### **Addendum 36: Regulation No. 37**

#### **Revision 7 – Amendment 4**

### **Uniform provisions concerning the approval of filament lamps for use in approved lamp units of power-driven vehicles and of their trailers**

Sheet PY21/5W/1

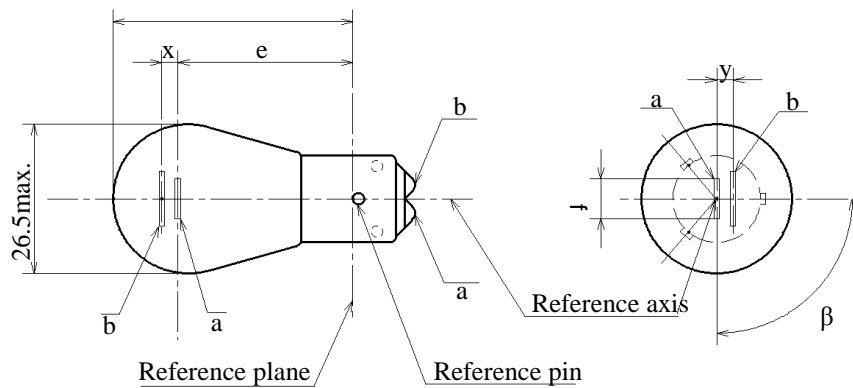
*Insert new sheets PY21/5W/1 to 3, between sheet PY21W/1 and sheet PY27/7W/1, to read:  
(see next pages)*

Standard filament lamp
				4/
				$28.6 \pm 0.3$
				$7.0 + 0/- 2$
				0.3 max.
				$2.8 \pm 0.3$
$90^\circ \pm 5^\circ$				
$[\text{xxx}]-1)$				
Rated values	Volts	12		12
	Watts	21	5	21/5
Test voltage	Volts	13.5		13.5
Objective values	Watts	26.5 max.	6.6 max.	26.5 and 6.6 max.
	Luminous flux	270	21	
	$\pm \%$	20	20	
Reference luminous flux at approximately 13.5 V				White: 440 lm and 35 lm Amber: 270 lm and 21 lm

- <sup>1/</sup> These dimensions shall be checked by means of a "box-system". See sheets PY21/5W/2 and PY21/5W/3. "x" and "y" refer to the major (high-wattage) filament, not to the reference axis.
- <sup>2/</sup> Maximum lateral deviation of the major (high wattage) filament centre from two mutually perpendicular planes both containing the reference axis and one containing the axis of the reference pin.
- <sup>3/</sup> The light emitted from normal production lamps shall be amber (see also note 4/).
- <sup>4/</sup> The light emitted from standard filament lamps shall be white or amber.
